S E R V I C E N O T E

8596E Spectrum Analyzer

Counter-Lock Assembly modification to improve marker count stability under certain conditions.

DATE: 09 August 1993

Figure 1. A25 Counter-Lock Assembly

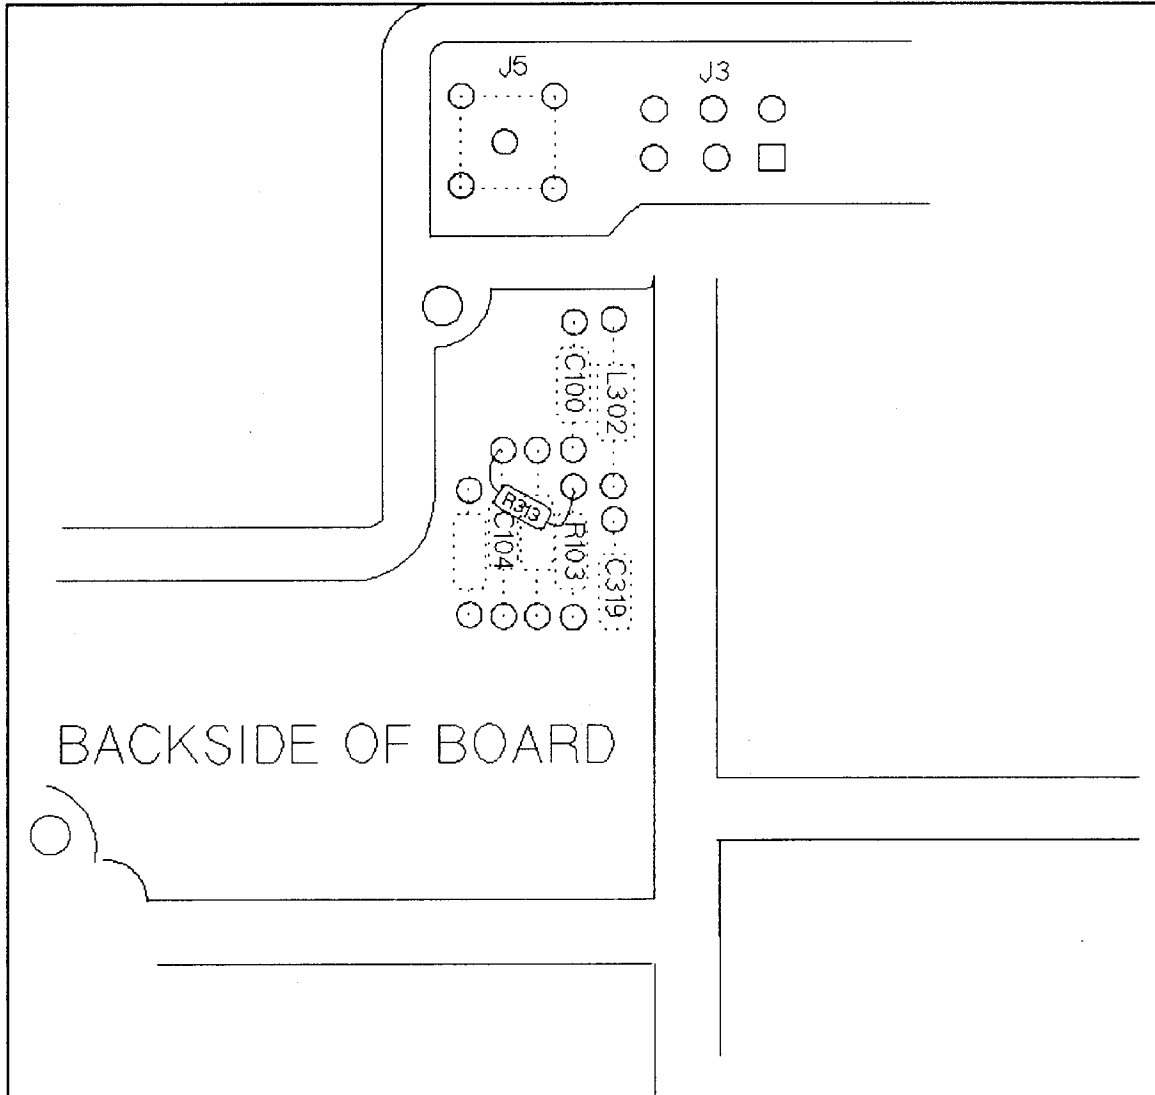
Instruments which have the A25 Counter Lock Assembly with P/N 08591-60053 or 08591-60061 may experience non-stable marker count readings. These non-stable counts are a problem while using marker count on AM modulated signals in wide Resolution BW's. When counting AM modulated signals (like the visual carrier of a TV signal) we have un-wanted modulation (15.7KHz sync rate) on the VIDEO_IF signal being combined with the COUNTER 21.4MHz input signal.

Add a high-pass filter circuit (corner freq of 1.4MHz) to the COUNT IF1(Block M) circuit which blocks the unwanted low frequency modulation signal and allows the 21.4MHz to pass through with very little loss.

1. Reference the A25 Counter-Lock Assembly Removal procedure. The procedure is located in the section of Service Guide labeled “Replacing Major Assemblies” on pages 7-41 and 7-42.
2. Remove the screw securing the two halves of the casting. Separate the casting halves and place the assembly bottom side up on the work surface.
3. Refer to Figure 1. for the location of R103 and remove R103. Install C321 in place of R103 but do not solder at this time. Install R313 as shown in Figure 1. One lead will share a hole with C321 (just installed). The other lead will share a hole with C104 as shown.
4. Apply the label (08591-60073) over the old board number.
5. Apply a label (08591-60073) onto the rear panel for future reference.
